Flight Design GmbH, Sielminger Str. 65, D-70771 L.-Echterdingen
e-mail: info@flightdesign.com
TEL +49 (0)711 90287-0 FAX +49 (0)711 90287-99

Technical Advice No.13
June 25th, 2007

CTSW2006 model year 2006 and 2007

Fig B1 & B2: Reinforcement installed to the trim tab
(Tab shown bottom surface facing up)

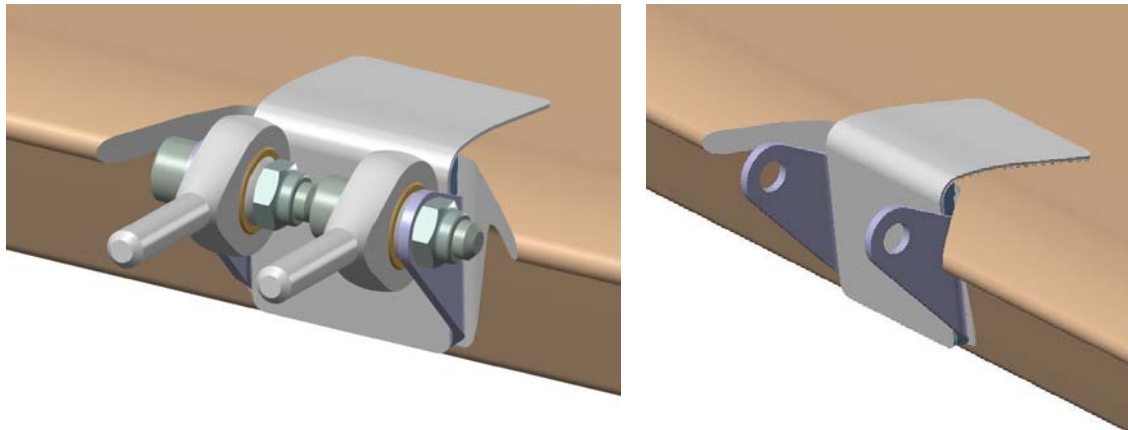
The reinforcement procedure consists of reinforcing the point at which the control horn is bonded to the trim tab by the addition of specifically designed part manufactured by Flight Design (WA 3011011). The part is glued (bonded) to the control rod bracket and the lower trim tab surface and delivers a secondary load path for the trim tab control forces. The modification can be done without removing the trim tab, and does not require painting action. (Figs.B1 & B2)

The procedure shall be completed according to Flight Design document: “070625 – TRIM TAB REINFORCEMENT PROCEDURE” that accompanies this Safety Directive, and supplemented by the Maintenance Manual.
